Union Street Apartments
 953 E Union Street, Seattle, WA

RECOMMENDATION MEETING
 JUNE 27, 2018
 PROJECT #3026031

2A HEIGHT, BULK, AND SCALE DIAGRAM

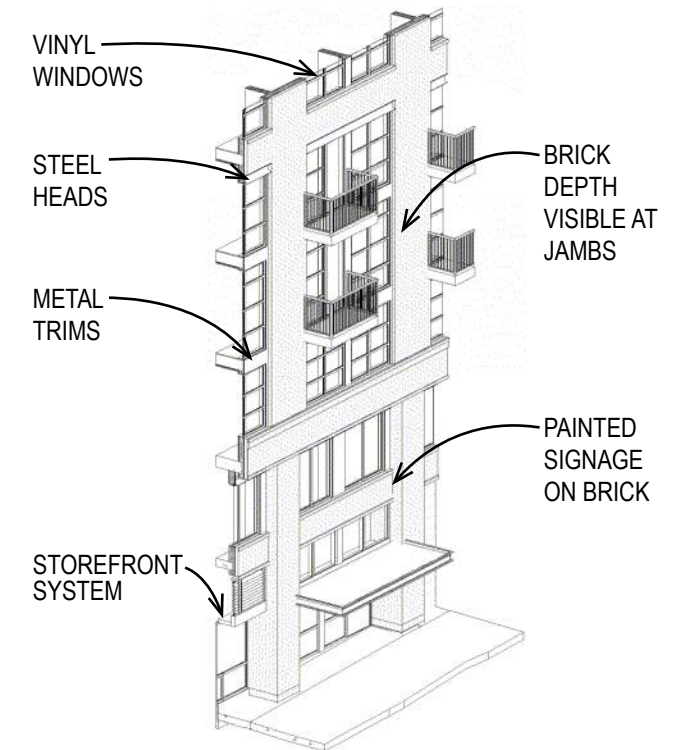
2A The Board appreciated the explanation of how major issues verbalized at the first EDG were addressed as they related to overall building height, window array and height, façade transparency and other design elements. (PP CS2-III, PP CS2-III-ia, PP PL3-II-ii, DC1-A-4)

RESPONSE: Proposal continues to refine the massing proposed to the Board at the Second EDG Meeting, maintaining the strong "base" of the building at street level with well-defined bays and the "loft style" window configuration of the residential tower.

5A GROUND LEVEL PLAN

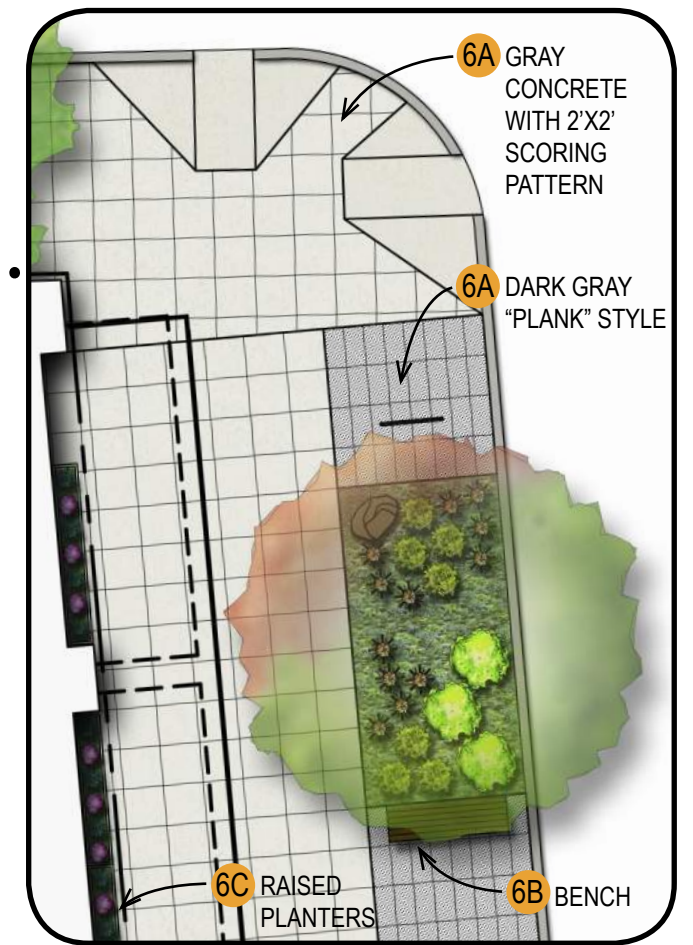
5A The Board agreed with the relocation of service uses designed to minimize their presence and create more transparency through the building per their EDG 1 guidance which provides flexibility to split the commercial floor area into many smaller spaces. The Board was also impressed with the number of recessed entries which they felt were playful and gave a contemporary feel to the project. (PL3-A-1, PL3-C, P CS3-II-ii)

RESPONSE: Proposal continues to refine the street-level proposed to the Board at the Second EDG Meeting, maintaining the entry insets and detailing the service bay inset space. Upon further deliberation with SDOT and SCL, the vault was relocated to 10th Avenue and enlarged to meet minimum requirements. The main residential entry has shifted further north to accommodate the required vault location and size. The ground floor commercial area has been divided into two spaces to relate to adjacent grade conditions.

6 LANDSCAPE PLAN

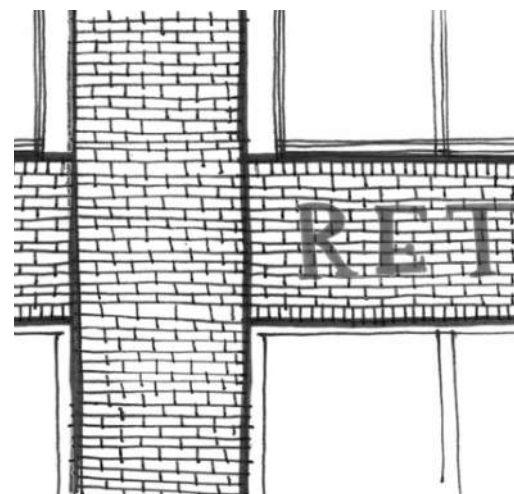
6A The Board encouraged the applicant to eliminate the different paving pattern at the corner of E. Union and 10th Avenue as they felt that it was disjointed and did not help in unifying the overall design character. (DC2-D2, PL1-C & DC3-A, DC4-II-i)

6B The Board suggested that the example of the bench depicted on page 21 of the Second EDG packet would not be 'user friendly' due to the middle bar which gives the impression of not being inviting and encouraged additional exploration of bench seating types. (PL1-B-2, PL1-B-3, DC1-A-2, DC3-C-2)

6C The Board encouraged further exploration of Broadway Ct to make it more pedestrian friendly and offer some green relief to a predominantly hardscape area. (PL1-B-2, PL1-B-3, PP P3-II-ii)

RESPONSE: Paving patterns and colors for pedestrian areas have been simplified to standard gray concrete with 2' square scoring pattern everywhere except the planter area along 10th Avenue. For this area we are proposing a different scoring pattern ("plank" style) and a darker gray concrete color.

RESPONSE: The bench with the middle bar was seen in the project vicinity and was considered for neighborhood consistency (similar with the proposed bike rack). The middle bar is assumed to be a deterrent to reclining or sleeping on the bench. The proposed will not include a middle bar, and will have a character and appearance consistent with the proposed building and neighborhood, refer to landscape exhibit sheets for imagery.

RESPONSE: To help make Broadway Court more pedestrian friendly and to provide some greenery, raised planters approx. 2' high x 15" wide have been added along the building frontage. Also, benches have been added adjacent to the building near the entry doors on 10th Avenue and Broadway Court, refer to landscape exhibit sheets for imagery.

7A BRICK BANDING BETWEEN COLUMNS AT EACH BAY

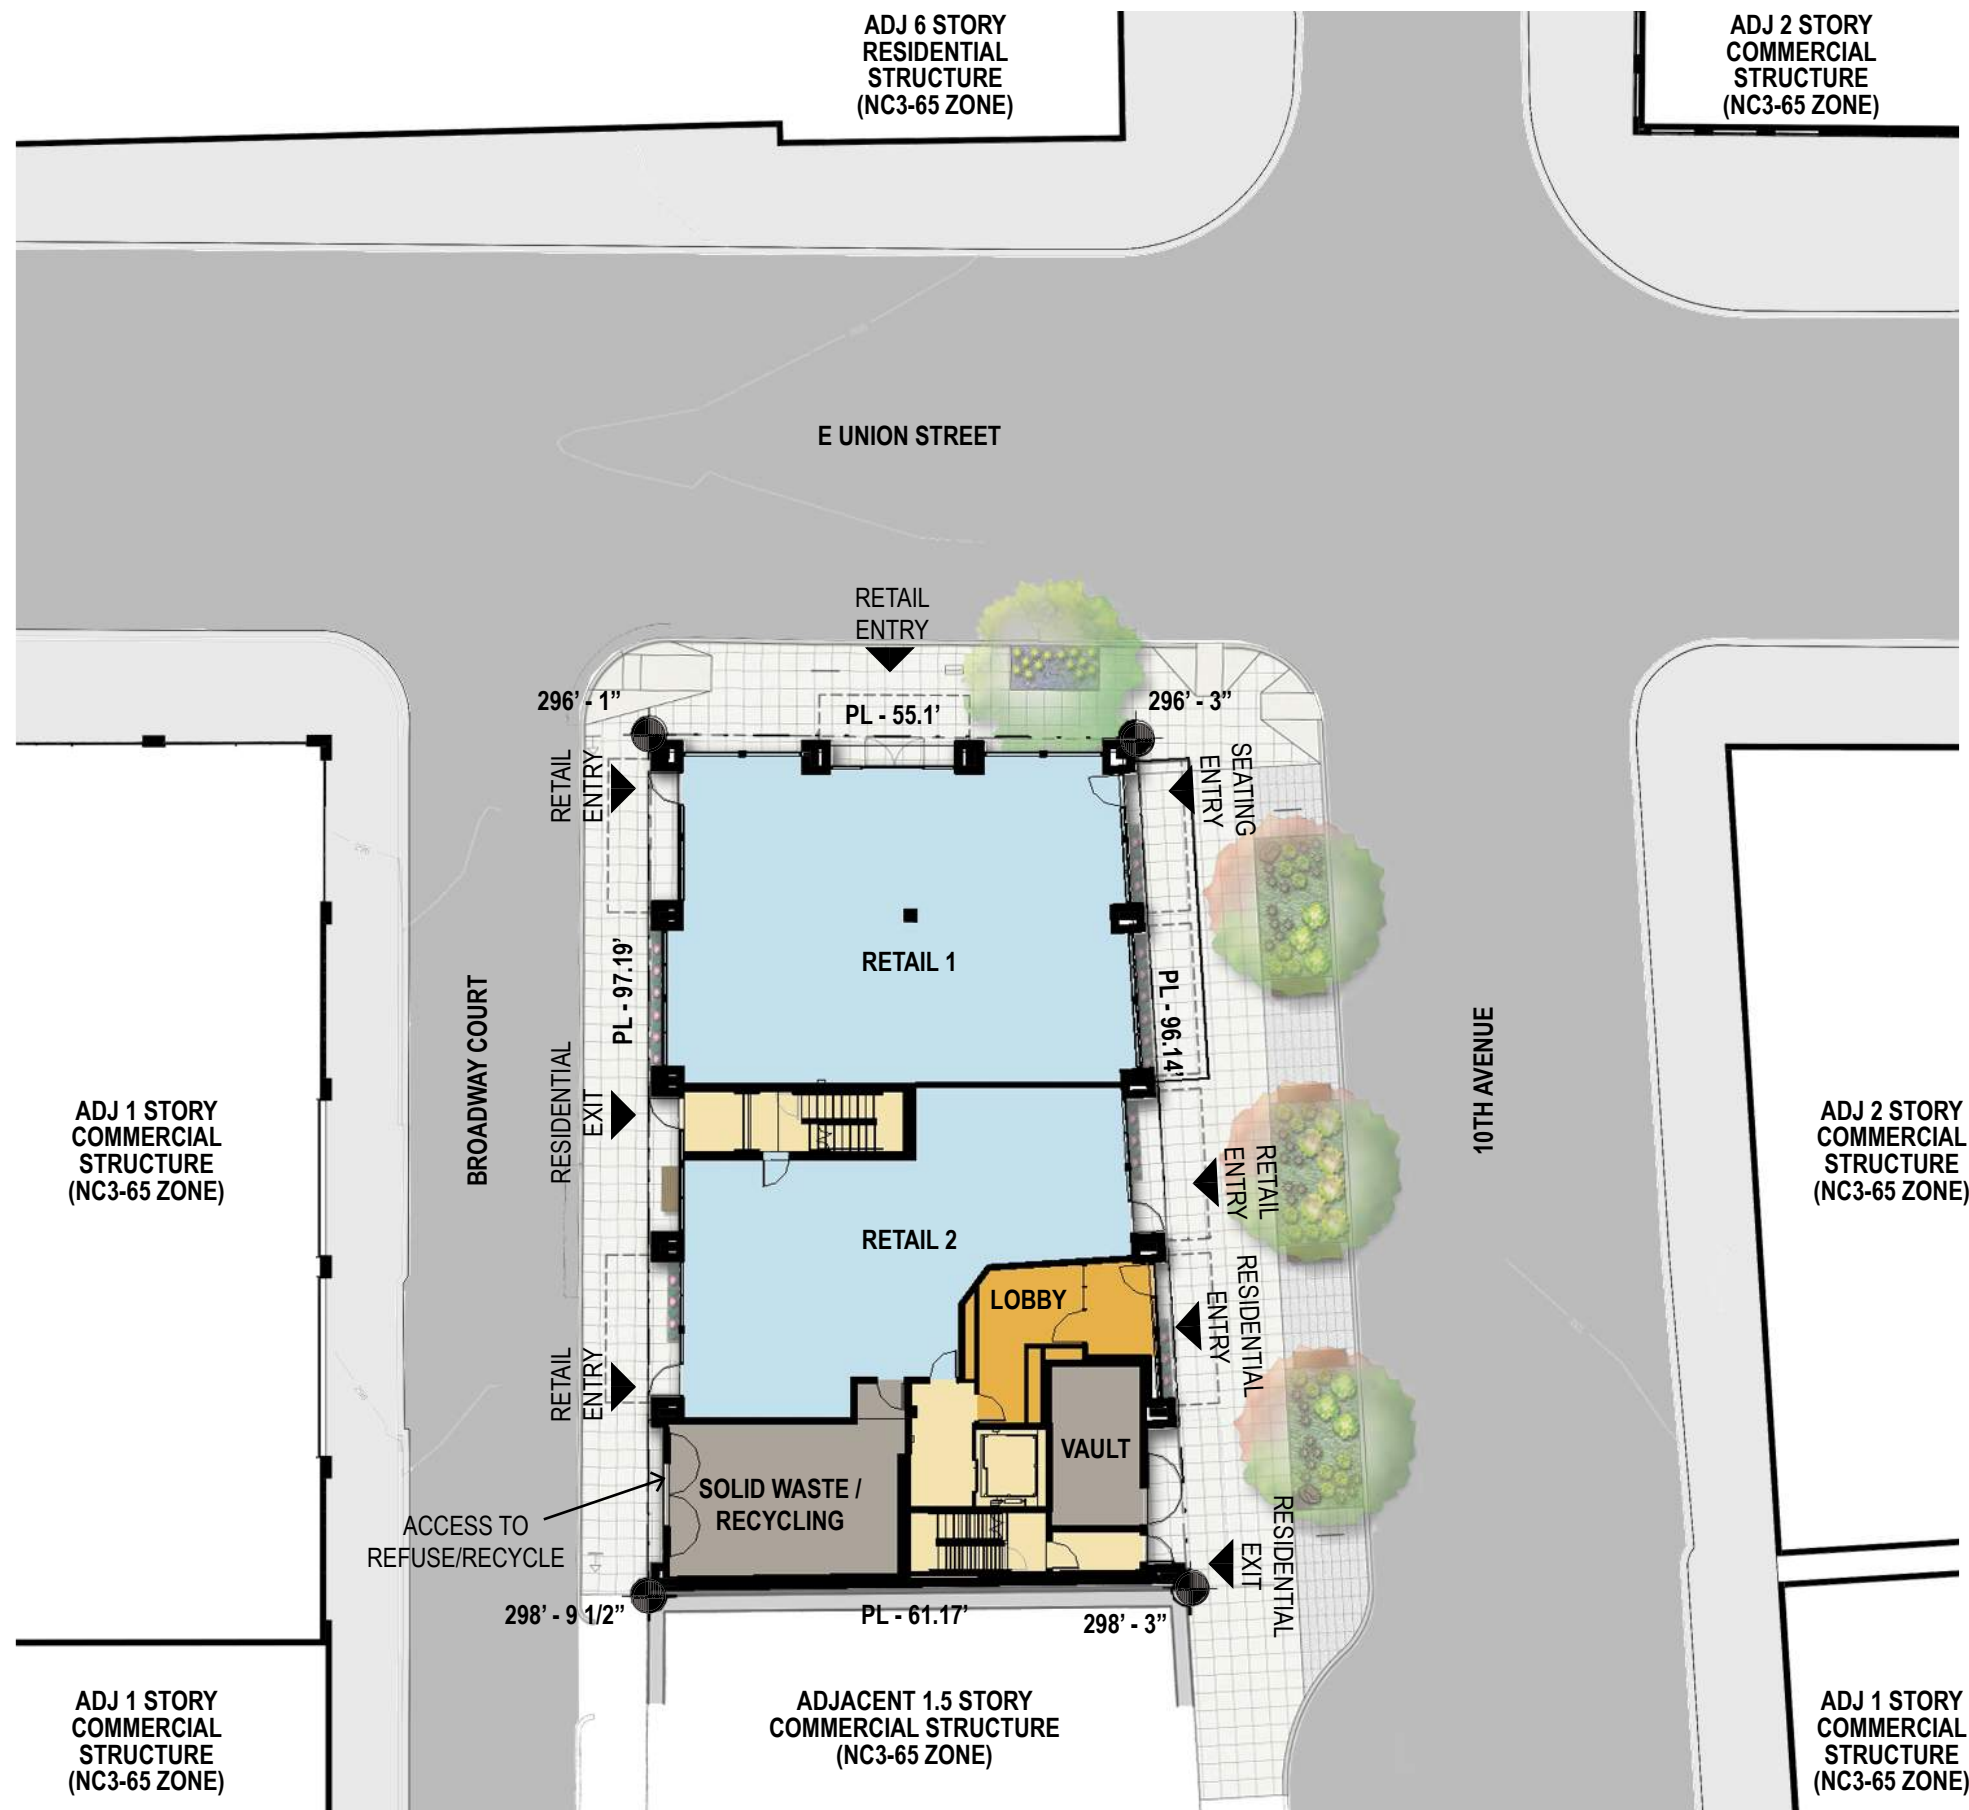
7A The Board had questions about the signage band to be located above the front entry and debated about the color and if the signage should be dark to continue the language at the base or whether the signage should just be painted letters on the brick façade or painted metal attached to the façade.

7Ai The Board asked the applicant to provide additional definition and design of what the signage might be and to make sure that it reinforces and reads as part of the opening of the front entry. (CS3-A, PP DC2-II-i, DC4-II-i and DC4-II-ii)

RESPONSE: The project proposes a brick banding at the floor level between the columns at each bay. The banding will be in a similar color to the adjacent brick columns and be bordered with a brick sill course at the top and bottom. Within the "frame" created by this sill coursing and the columns, signage may be painted at any bay for both the tenant space(s) and the residential tower. Proposal shows tenant name locations at entry points and opportunities for additional signage or tenant related painted imagery at other bay locations, refer to signage exhibit sheet for more information.

DEPARTURE REQUESTS

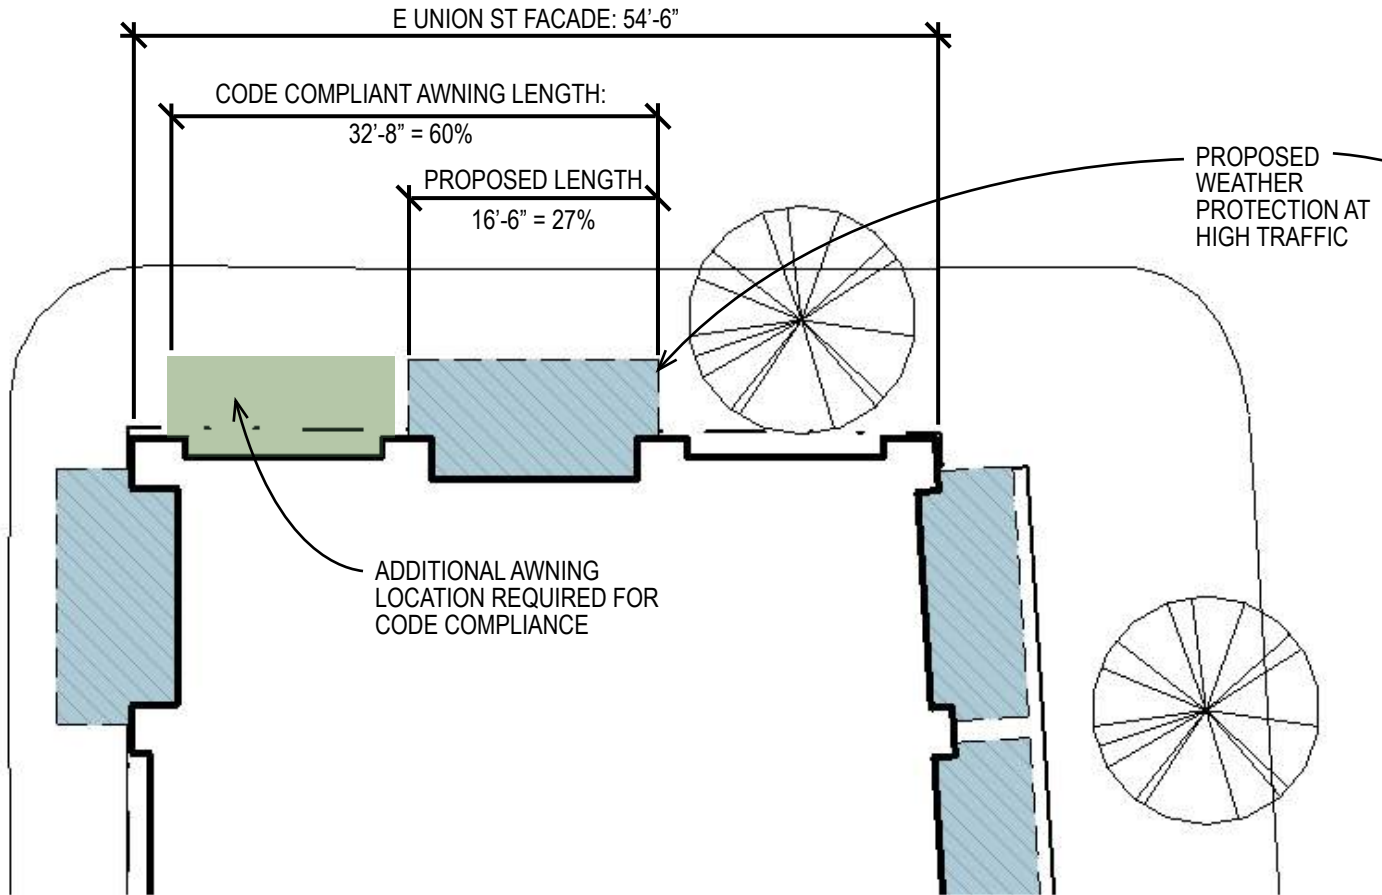
departure request for less than 60% overhead protection along E. Union Street

DEPARTURE NUMBER	LAND USE CODE SECTION	ITEM	CODE REQUIREMENT	DEPARTURE REQUESTED	DESIGN RATIONALE
1	SMC 23.47A.008.C.4.a	Overhead weather protection is required along at least 60% of the street frontage on a principal pedestrian street.	<p>Union St. is a designated "principal pedestrian street". Code requires that 60% of the Union frontage provide overhead protection.</p> <p>Union facade length = 54.5 feet</p> <p>Weather protection at 60% of frontage = 32'-8" of required overhead protection (54.5'x0.60)</p>	<p>Along E. Union St., the project proposes to provide continuous weather protection for a total length of 16'-6" which is 30% of the overall facade length. This is less than the code requirement.</p>	<p>By locating an awning only at the retail entry along E. Union, the project provides entry location overhead protection while increasing the visibility of the architectural features, such as the transom windows, brick detailing, and signage. Further, the reduced overhead protection reinforces the existing urban context where awnings are limited on historical groundlevel storefronts. (PL3.C Retail Edges & CS3.IV Architectural Context)</p>
